**Marion County
Board of County Commissioners**

**PLANNING & ZONING SECTION
STAFF REPORT**

P&ZC Date: 04/29/2024	BCC Date: 05/21/2024
Case Number	240205ZP
CDP-AR	30892
Type of Case	Rezoning from Single-Family Dwelling (R-1) to Planned Unit Development (PUD) to allow a maximum of 337 single-family residences.
Owner	Ocala 85, LLC.
Applicant/Agent(s)	JMJ Group, LLC. – Gerald J. Pionessa, Jr., P.E.
Street Address / Site Location	No address
Parcel Number	37515-000-01; 37515-000-05
Property Size	±84.37 acres
Future Land Use	Medium Residential (MR)
Zoning Classification	Single-Family Residential (R-1)
Overlay Zone/Scenic Area	Urban Growth Boundary (UGB), in the Silver Springs Primary Protection Overlay Zone (SSPOZ)
Staff Recommendation	APPROVAL WITH CONDITIONS
P&ZC Recommendation	DENIAL
Project Planner	Kathleen Brugnoli, Planner II
Historic/Related Case(s)	None

**Figure 1
Conceptual Plan**

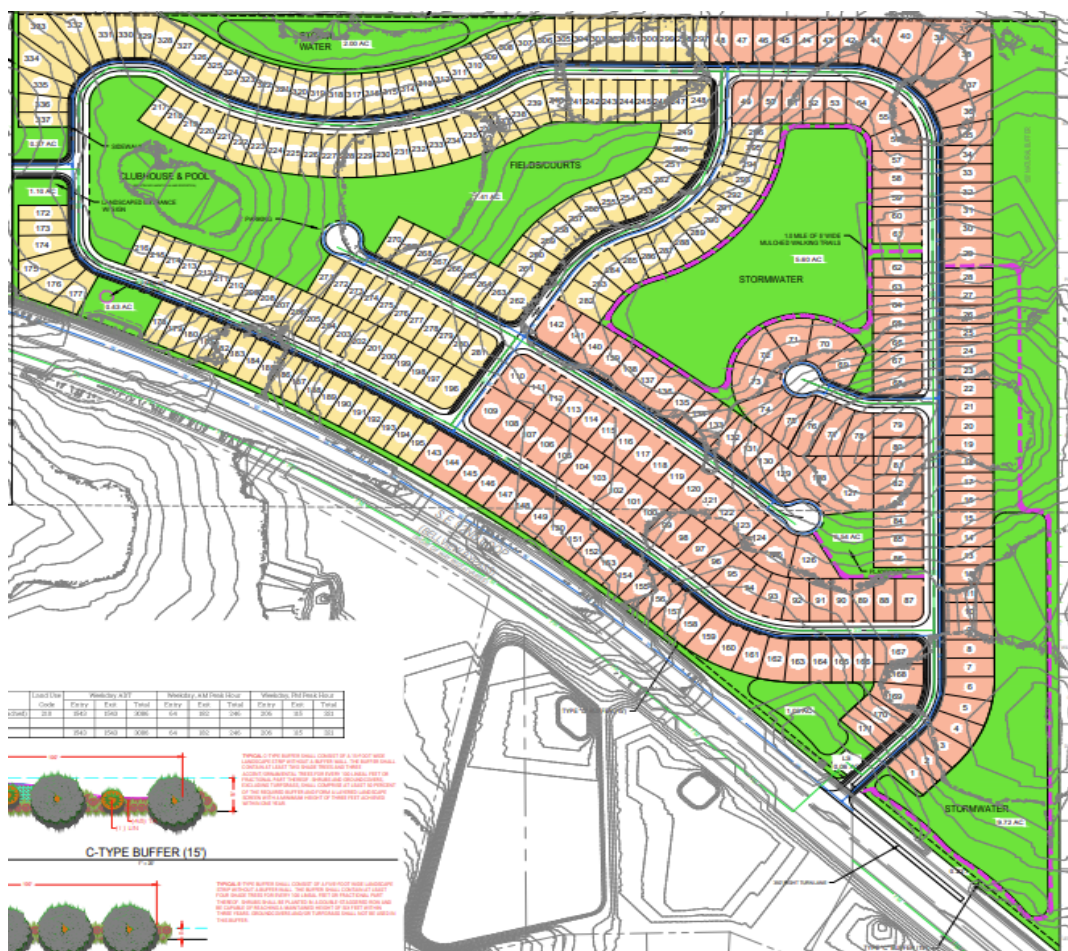
Analysis: The PUD Plan shows internal access provided by sidewalks throughout the subdivision. Sidewalks external to the project are already existing on this portion of SE 92nd Loop. **Staff has recommended a development condition, and as such staff finds the application is consistent with this provision.**

Analysis: Detailed building separations were not provided within the PUD Plan; however, such details will be required by the site's final development review plans. As noted, building separations are also subject to building and fire safety codes which allow some design and construction flexibility. As such, staff recommends a development condition to ensure the PUD will be **consistent with this section**.

Analysis: Plan notes provided on the PUD Plan list the maximum building height of 40-feet but a typical illustration showing the maximum height was not provided.

Analysis: The PUD Plan does not display the location of exterior lighting. As such, *staff recommends the PUD site comply with the County's LDC lighting standards that require lighting be shielded so as to not cast direct lighting off-site and a photometric plan be provided during major site plan review to ensure no negative impacts to neighboring parcels.*

Analysis: The PUD plan provides open space calculations; the required 20% minimum being 16.87 acres and the total provided (including open space, DRA's, and buffers) being 20.3 acres, or 24.1% of the site.

- *PUD site must comply with the County's LDC lighting standards that require lighting be shielded so as to not cast direct lighting off-site and a photometric plan be provided during major site plan review to ensure no negative impacts to neighboring parcels.*
